**SAFETY BULLETIN : OTIS**

POTENTIAL SAFETY HAZARD

UK Corrective Instruction

OVF 30 drives on units without brake switches fitted

Pic 1: Depth

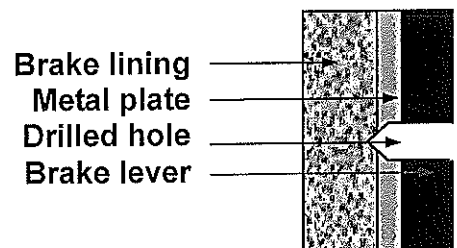
- a) Main switch switched off and Locked and tagged out.
- b) Drill a hole 5,2-5,5 mm or 7,2-7,5 mm (according to depth) into brake shoe so that it only just penetrates the brake shoe lining (See picture 2).

To assure the right depth, it should be marked on the drill (picture 1)  
This has to be done very carefully.

**Pic 3: Thermal conduction paste**

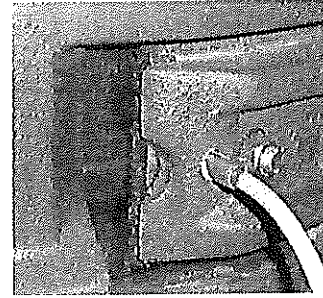
- c) Put some thermal conduction paste into the hole.  
(Picture 3)

**Pic 5**

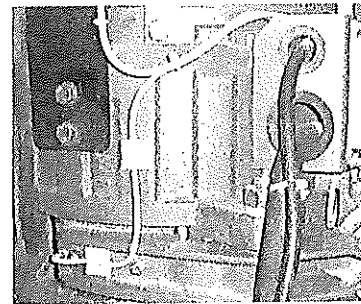
The leads of the thermal fuses have to be fastened to the machine using adhesive clips (picture 5).

To fix the adhesive clips, the positions have to be clean of grease and dust. The adhesive clips near the thermal fuse must not put unnecessary pressure onto the Thermal fuse. The cable is to be fastened with a cable tie to prevent movement.

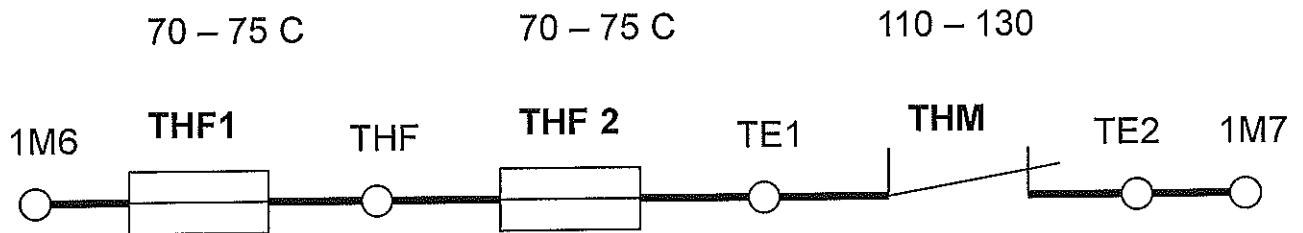
- f) The thermal fuses have to be connected in series with the motor thermistor (THM) in the connection box on the machine. The connections of the thermistor (THM) are marked as TE1 and TE2. Connect in series the thermal fuses to TE1. See typical wiring diagram below. Check on site wiring diagrams for connections

Pic 6

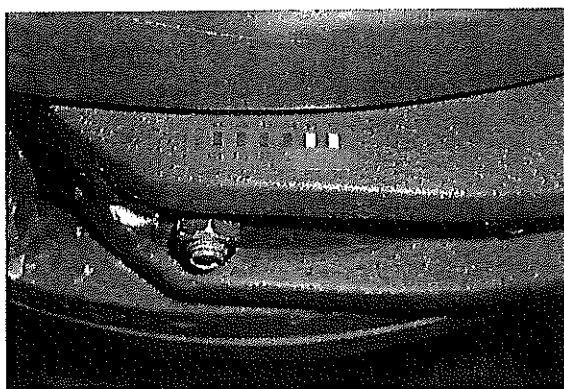
g) In addition a 6-step temperature sensor should be fixed near the brake linings  
(See picture 6)

In normal operation none of the temperature fields should have changed to a dark state  
(See picture 6).

Decoloured fields (>44 degrees C) indicates  
Possible brake problems. This has to be  
checked (see picture 7)
